Staff Report

To: Salt Lake City Planning Commission
From: Casey Stewart; 801-535-6260
Date: January 2, 2018 (For January 9 hearing date)
Re: PLNSUB2017-00812 Svendsen Condominiums Planned Development

PLANNED DEVELOPMENT

PROPERTY ADDRESS: 48 East 1700 South
PARCEL ID: 16-18-160-001
MASTER PLAN: Central Community Master Plan
ZONING DISTRICT: CC (Corridor Commercial)

C1 NORTH ELEVATION
SCALE: 1/8"=1'-0"

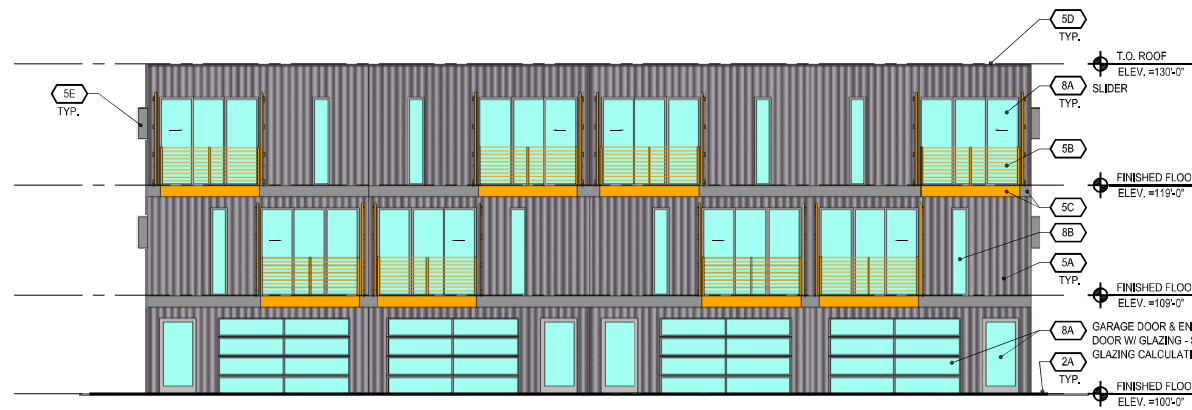
1. Final planned development plan approval is delegated to the Planning Director.
2. Part of the final approval requires the applicant to include at least three additional architectural features on the ground level façade facing 1700 South, or;
3. The applicant may make the following changes along the ground level façade facing 1700 South: convert the windows at the west end of the façade to an entrance door with windows, maintaining the required amount of transparent glass, and add a canopy over the entrance door.

Issue 2: Pedestrian engagement along 1700 South

The proposed façade along 1700 South lacks architectural features and visual interest that serve as pedestrian engagement. This item is listed as a planned development standard focused on pedestrian interest and interaction for facades that face a public street. Planning staff raised this concern with the applicant, but the applicant prefers to leave the 1700 South façade as proposed. This situation has resulted in "conditions of approval" recommended by planning staff on page one of this report, which would require at least a few features or changes (such as a canopy over the doorway and moving the entrance door to the building corner in an effort to increase its potential as the main entrance) be added to the 1700 South façade.
